MEMORANDUM

TO: SQZ team
FROM: Daniel Sigg, Marc Pirello
SUBJECT: Modifications to the TTFSS V4
Refer to: LIGO-E1700364-v3

This document lists the modifications to the 4th generation TTFSS, based on PCB D1700346-v1 and on schematics [D1700077](#), [D1700076](#) and [D1700078](#).

Change 1:

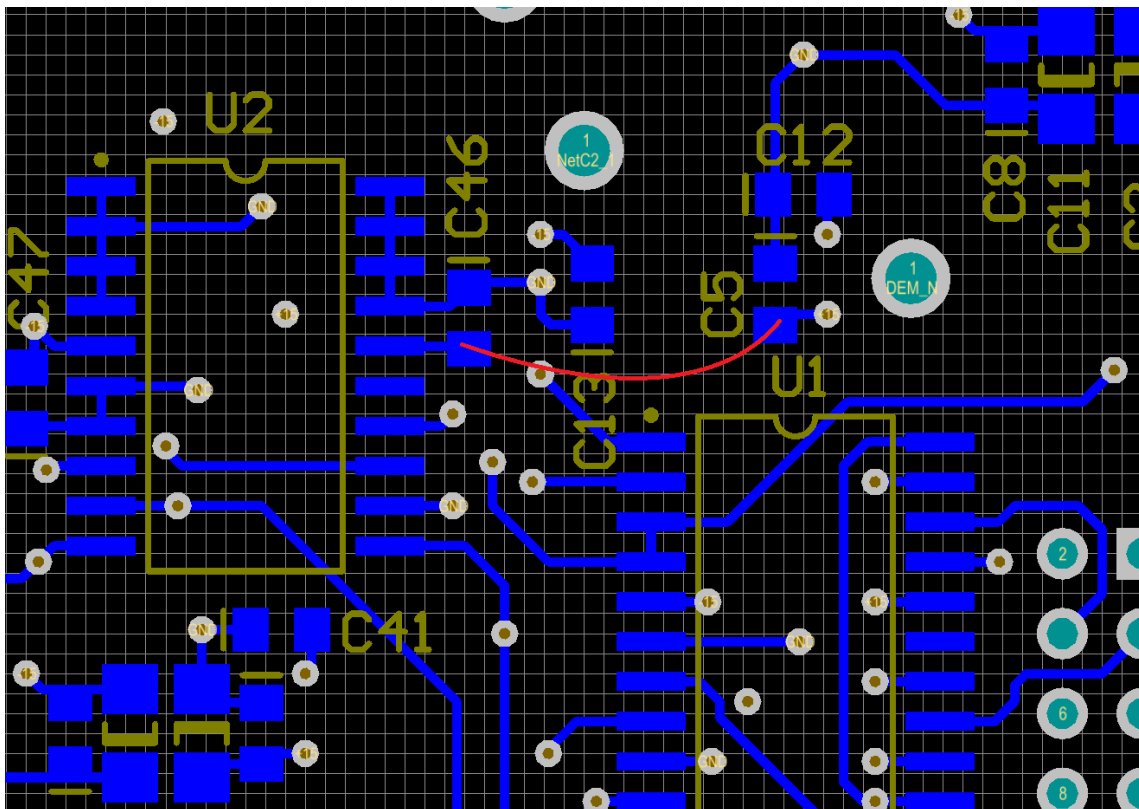
U2 is missing the +15V rail. Add a jumper wire between the C5 pad towards U1 and the C46 pad towards U1 (Servo board, D1700077, bottom).

Change 2:

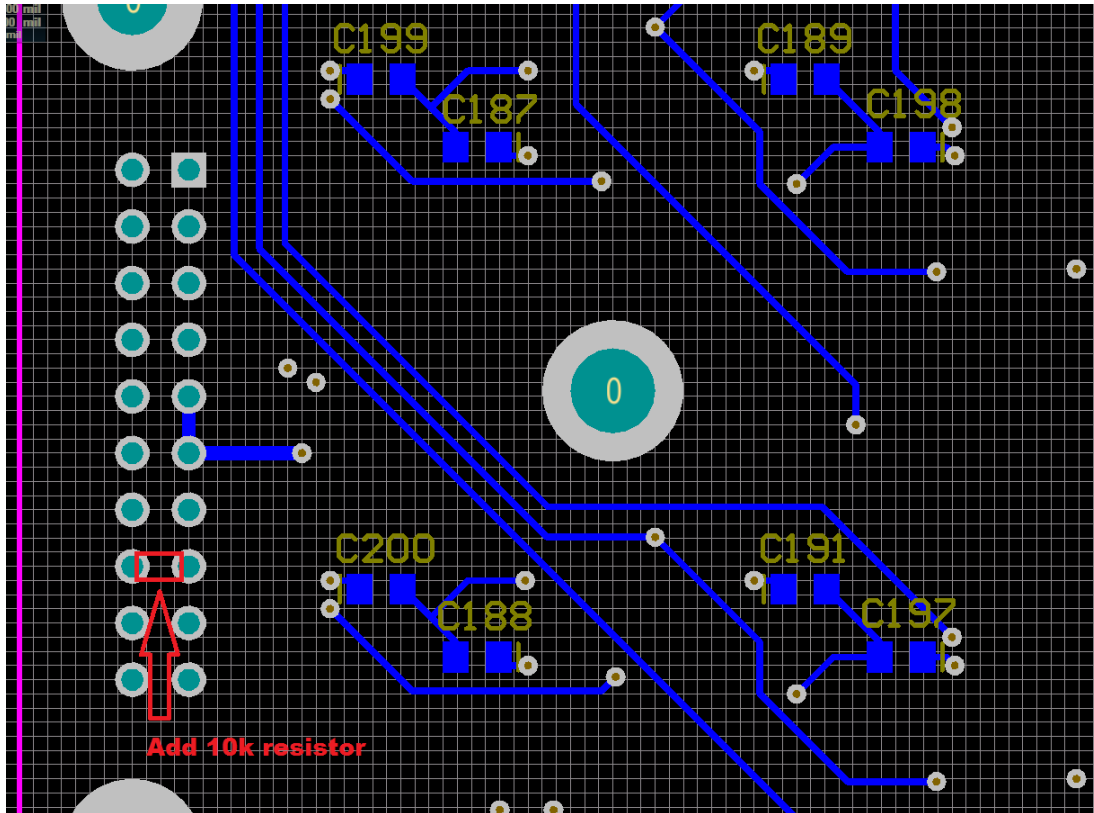
Input to U26 is floating when OPT4 is selected without an option board. Add a 10 k Ω resistor (R174) between pins 8 and 18 of header JP1 (Servo board, D1700077, bottom).

Change 11:

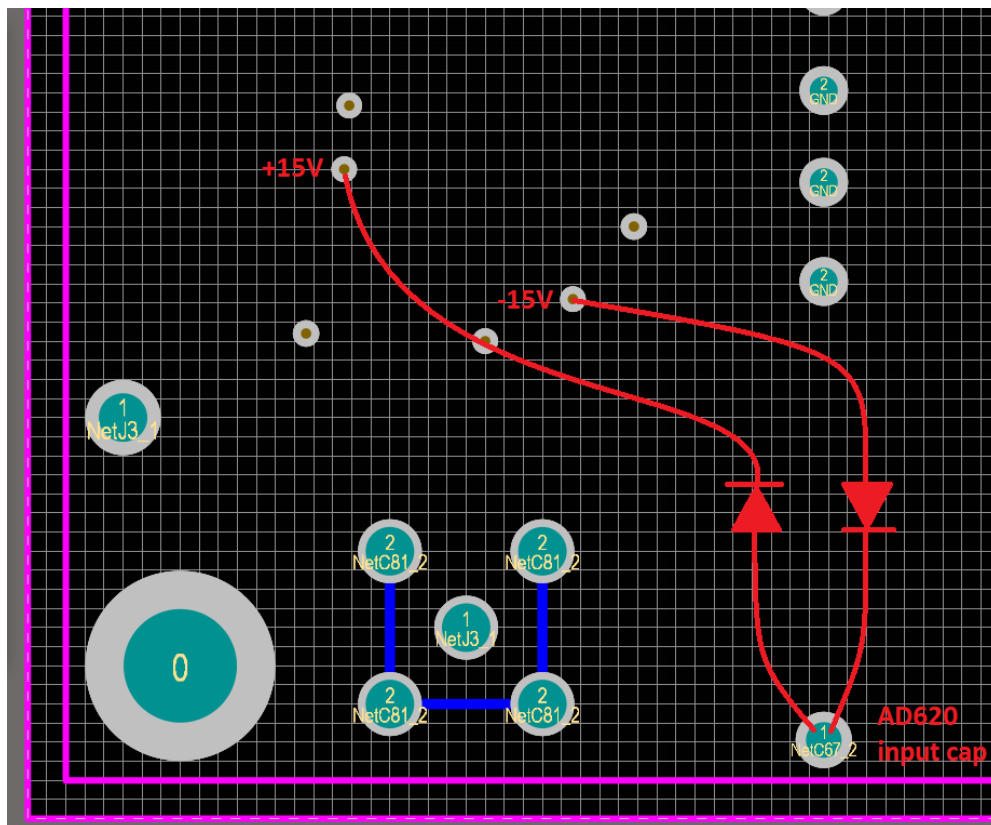
Add protection diodes between the AD620 inputs and the supplies to discharge the input capacitor upon power failure (HV board, D1700076, bottom).

Bottom of HV board, D1700076, beneath U17, AD620.
